CHRISTCHURCH CATHEDRAL PROPOSED REINSTATEMENT

Heritage Report

Prepared for the Cathedral Working Group

November 2016

2. Core and drill

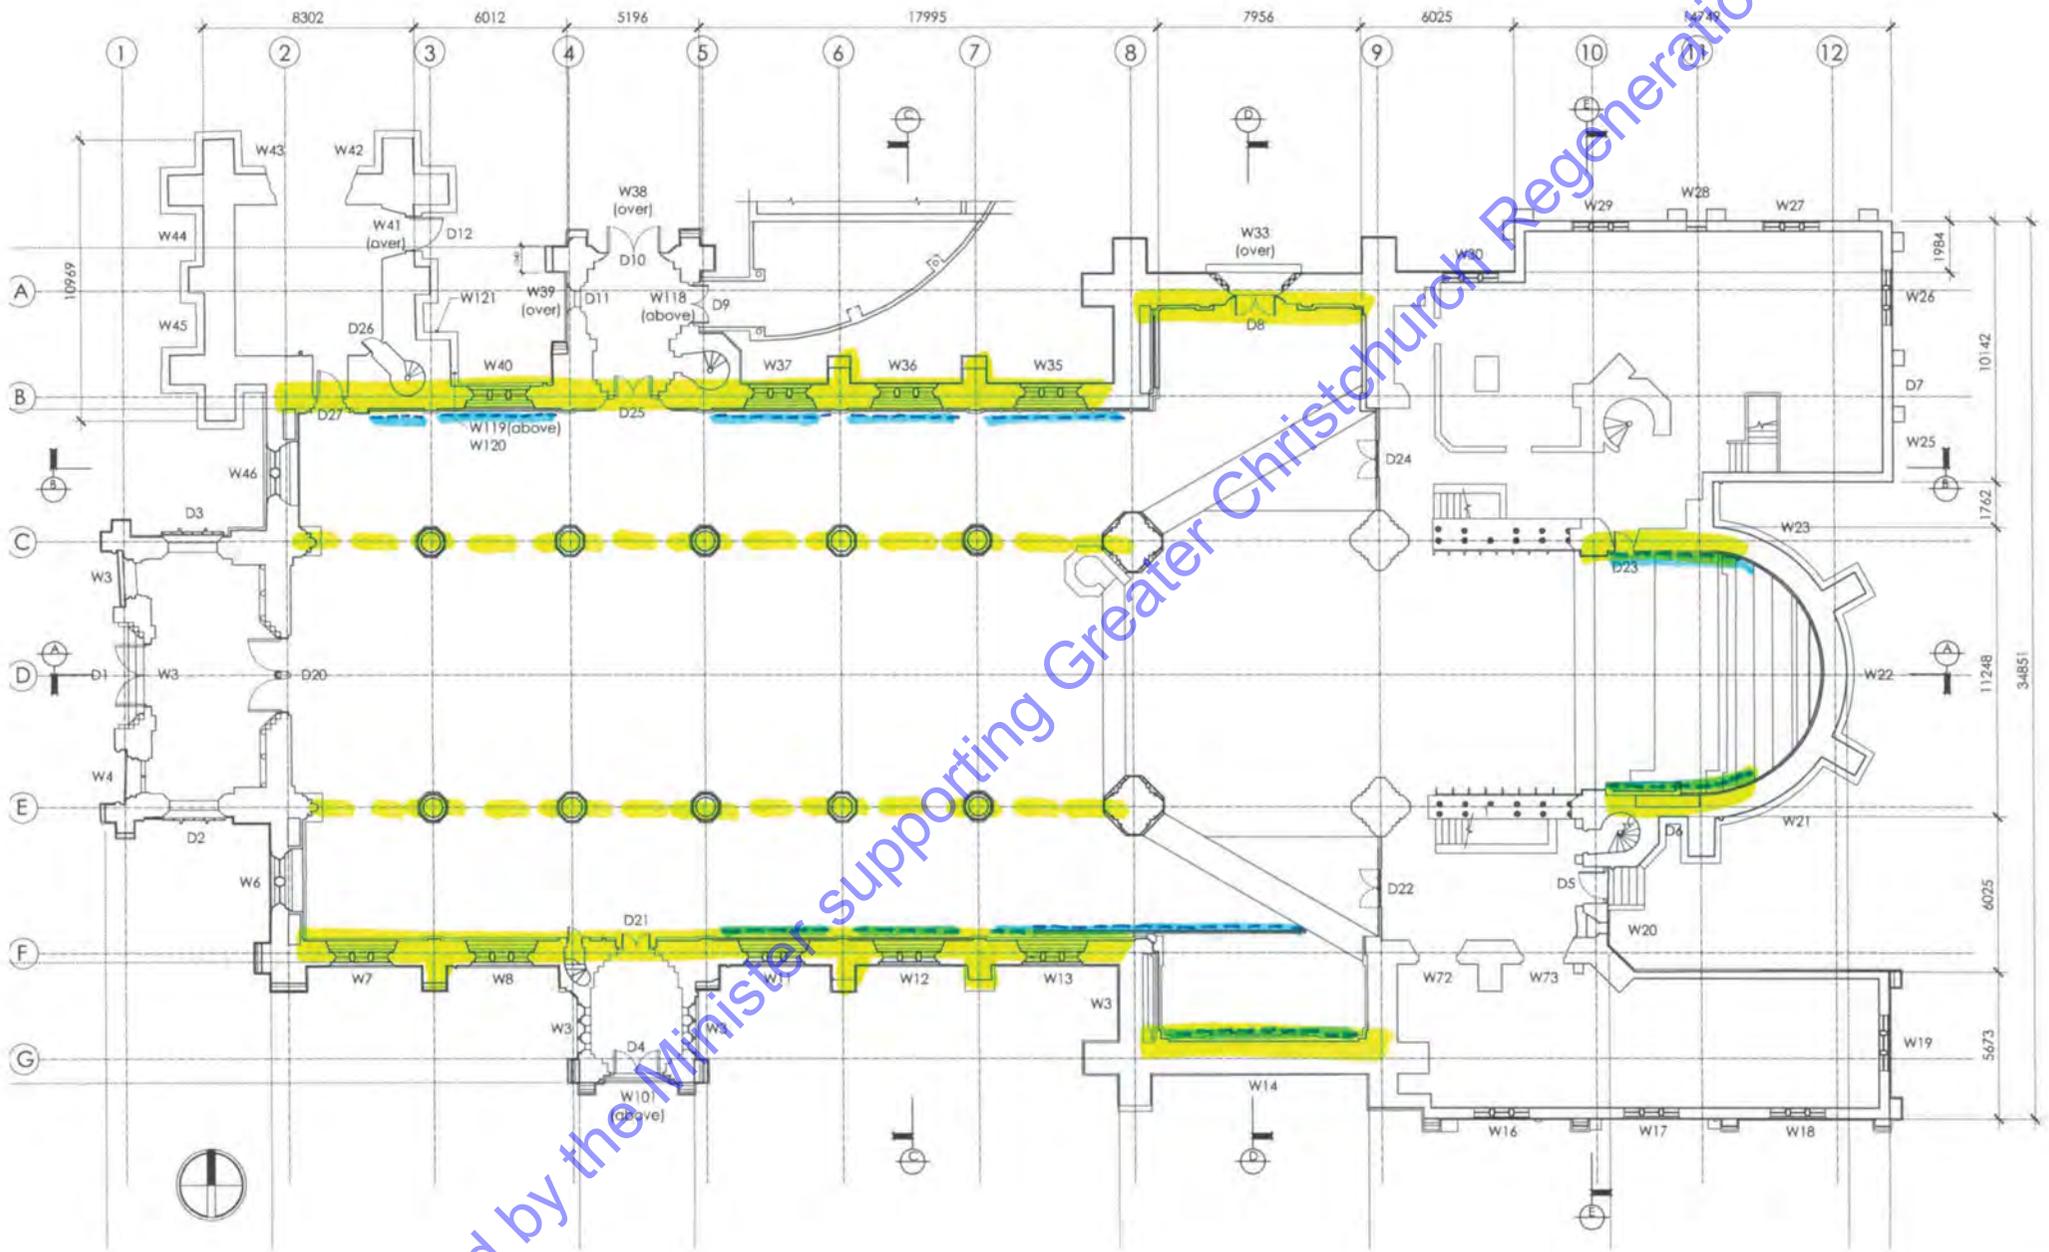
HCG propose the use of this strengthening technique to all the walls which have suffered large amounts of movement and displacement. This is most apparent in the side walls of the aisles and buttresses, the transept gable walls and in the chancel.

This technique has been applied extensively and successfully in the Christchurch Arts Centre and its effect on heritage values is low.

The technique allows the architectural form of the exterior walls to be retained, often in situ, and this is closely linked to the architectural, aesthetic, cultural and contextual values of the Cathedral. However, the technique also requires the loss of the internal inner stone linings and some of the rubble core and this affects the authentic technological values of the original masonry construction and the interior architectural and aesthetic values.

3. Replace core with reinforced concrete
 (note non-structural fabric attached to existing walls)

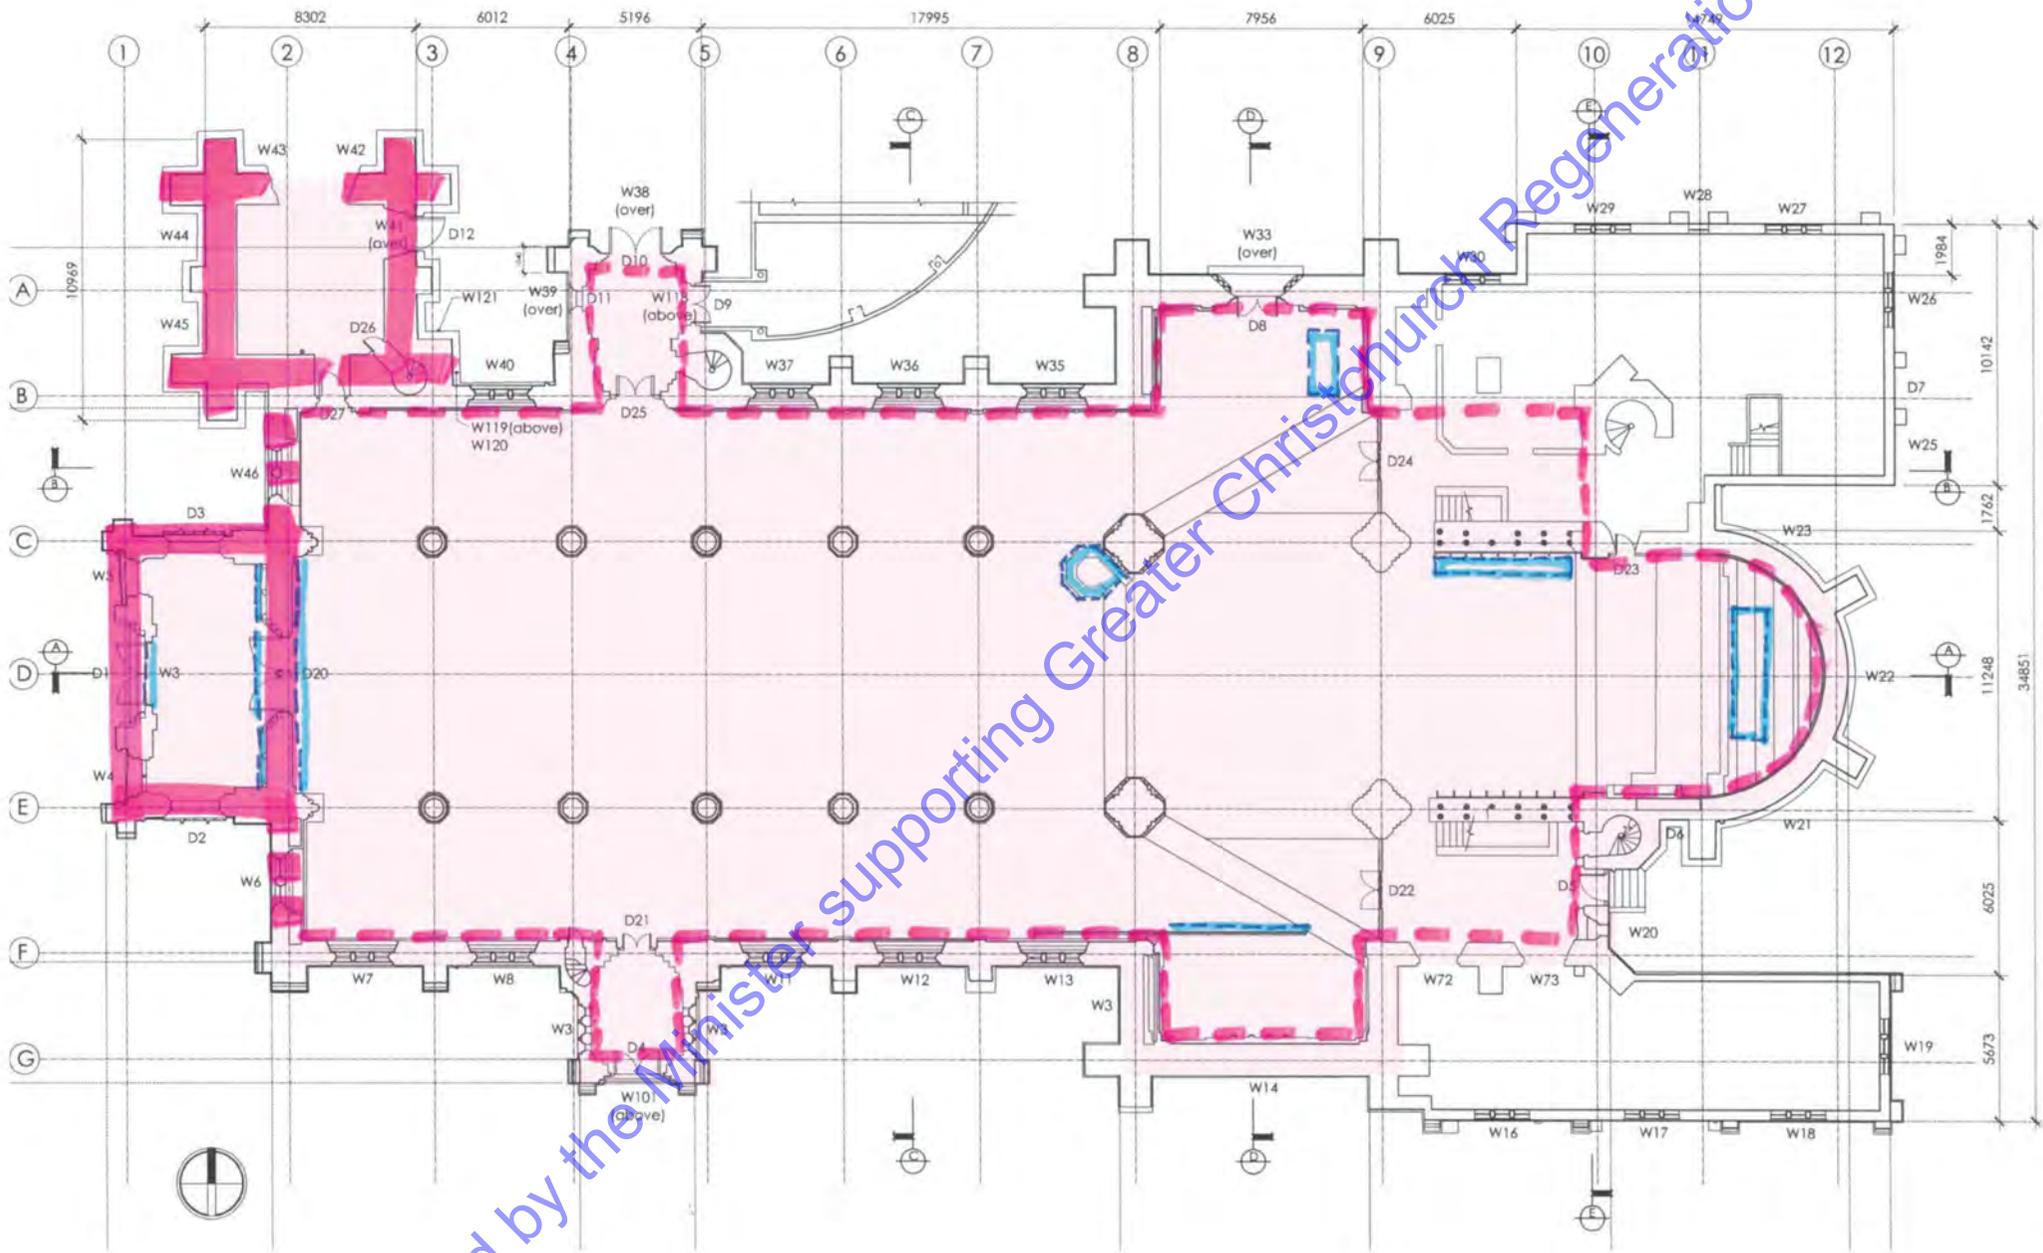
It may be possible to avoid widespread loss of some of the carved decorative stone elements of the internal linings, such as string course and window facings, with suitable methodologies once the building is stabilised.

The interior limestone linings are not actually continuous within the interior, with some areas of the interior walls remaining as exposed rubble core or covered in panels of tiles or memorial tablets. The explanation for this is understood to be that the Cathedral was not "finished" and that its completion is an ongoing process. Replacement of the limestone linings is therefore seen as a measure with low impact on the overall heritage values of the Cathedral.
